**Subject: Geotechnical Response to Review Comments
Proposed Residence
5236 West Mercer Way
Mercer Island, Washington 98125**

Reference: Geotechnical Engineering Report, Proposed Residence, 5236 West Mercer Way, Mercer Island, Washington, prepared by PanGEO Inc., dated October 5, 2017.

As requested, the following letter is provided to address review comments put forth in the City of Mercer Island Review Letter dated February 5, 2018, regarding the above-referenced project. Item numbers 22 through 26 of the Correction Notice concerns geotechnical subject matters, and are addressed below.

**TYPICAL SCHEMATIC SECTION
GABION BASKET WALLS**

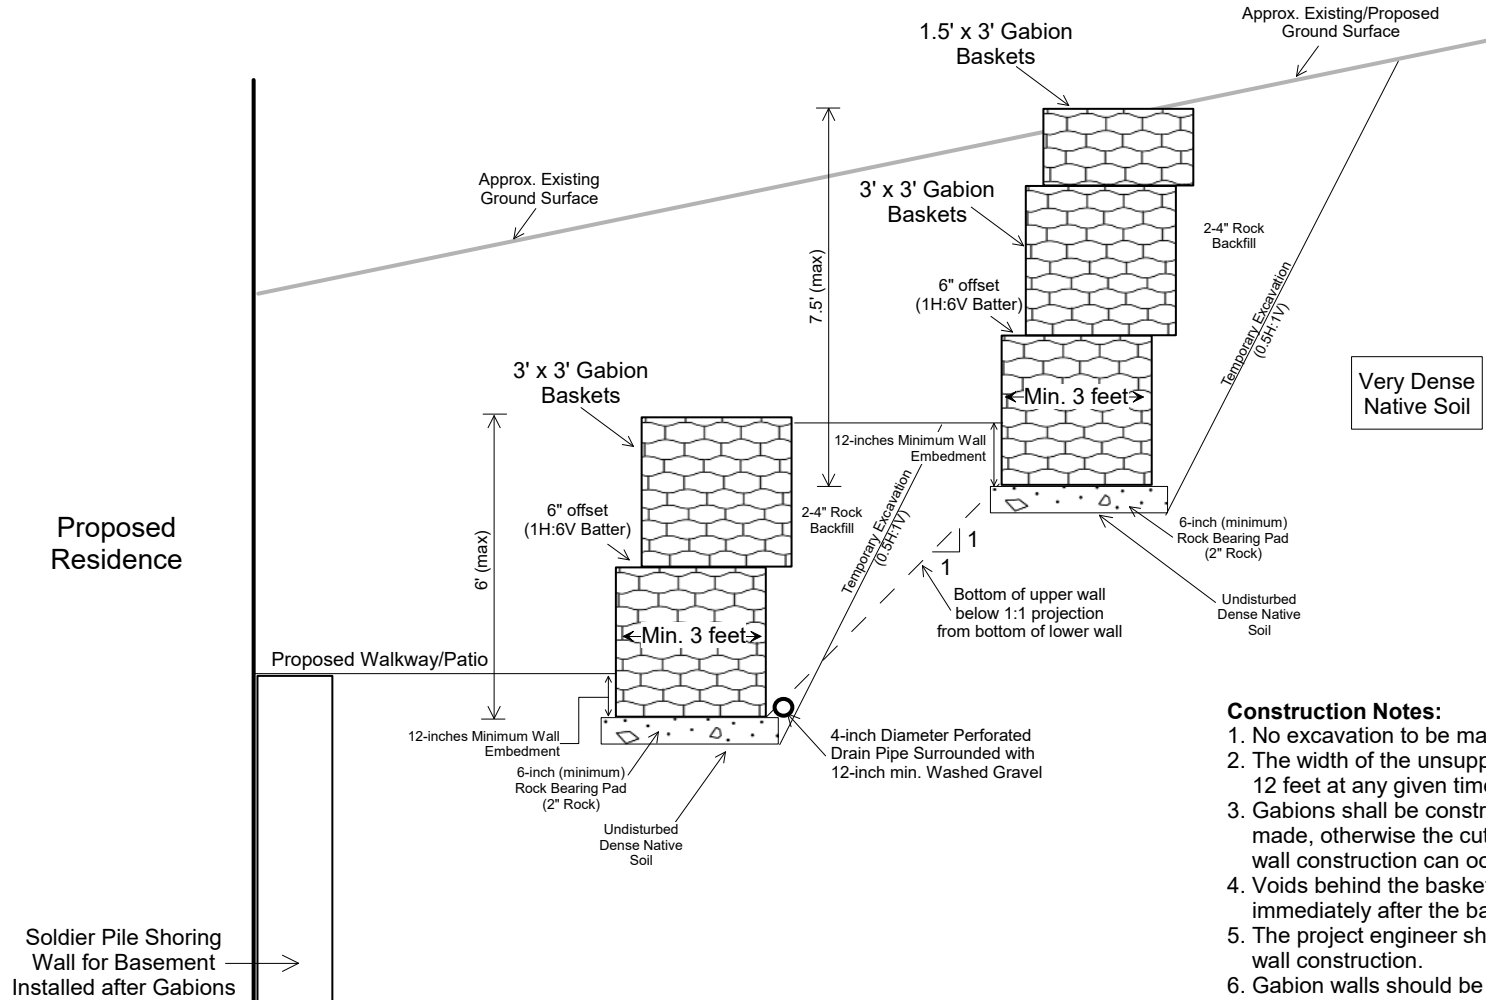
Items 24 & 25: Soils to be Exposed in Permanent Cut

The previously proposed permanent 2H:1V cut slope east of the proposed house has been eliminated and replaced with a tiered gabion basket wall. Our original report provided general recommendations for gabion basket walls at the site, however, we have prepared a specific gabion basket wall design for the sloping areas of the site north and east of the proposed residence. Please see attached Figure A for a typical schematic section of a gabion basket wall north and east of the proposed residence.

As described above, the proposed permanent 2H:1V cuts to the north and east of the house have been replaced with gabion basket walls to significantly reduce the disturbed area of the site, and prevent grading from impacting tree protection areas.
